Access Compliance Report

Public Rights-of-Way

(Curb Ramps)

Intersection ID: 14189	Main Street: E_KINGSTON_AV	Cross Street: EUCLID_AV	Location:	N
ADA ID: 385D3B0B46F2	Ramp Type: Perp	Initial Pass/Fail: Fail	Overall Compliance: No	Severity Score: 1.25

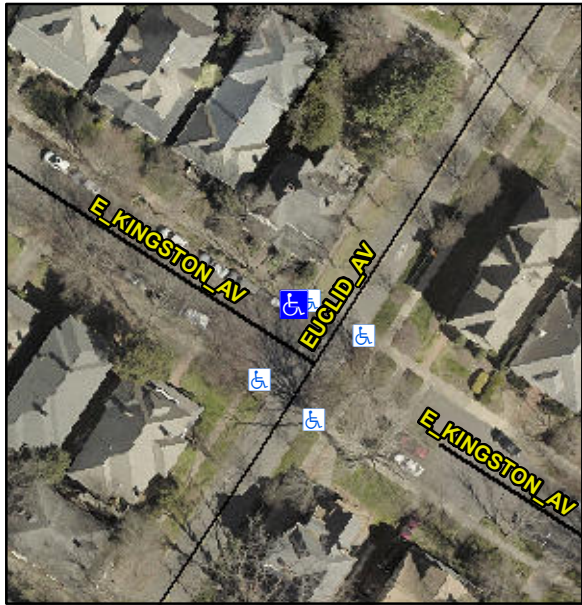
Codes/Mitigation Info/Possible Solution			Field Measurements/Component Compliance					
	Possible Solutions:		Compliance	Description	Data	Compliance	Description	Data
	Remove & Replace Entire Ramp.		N/A	Ramp Length (in)	48.0	Yes	Ramp Slope (%)	6.8
			Yes	Ramp Width (in)	60.0	No	Ramp XSlope (%)	2.5
			N/A	Flare Type LT	N/A	N/A	Flare Type RT	N/A
			N/A	Flare Slope LT (%)	N/A	N/A	Flare Slope RT (%)	N/A
			N/A	Flare Traversable LT?	N/A	N/A	Flare Traversable RT?	N/A
			N/A	Landing Length (in)	N/A	N/A	DWS Provided?	N/A
			N/A	Landing Width (in)	N/A	N/A	DWS Contrast?	N/A
			N/A	Landing Slope (%)	N/A	N/A	DWS Length (in)	N/A
			N/A	Landing X Slope (%)	N/A	N/A	DWS Full Width?	N/A
Surveyor Notes:			N/A	Landing Curb? (Y/N)	N/A	N/A	DWS Offset (in)	N/A
PROW/ADA:			N/A	Shared Landing?	N/A			
R304.5.3			N/A	Gutter Ponding?	N/A	N/A	Gutter Slope (%)	N/A
			N/A	Gutter Lip Ht (in)	N/A	N/A	Gutter X Slope (%)	N/A
			N/A	Painted X Walk1?	No	N/A	Painted X Walk2?	N/A
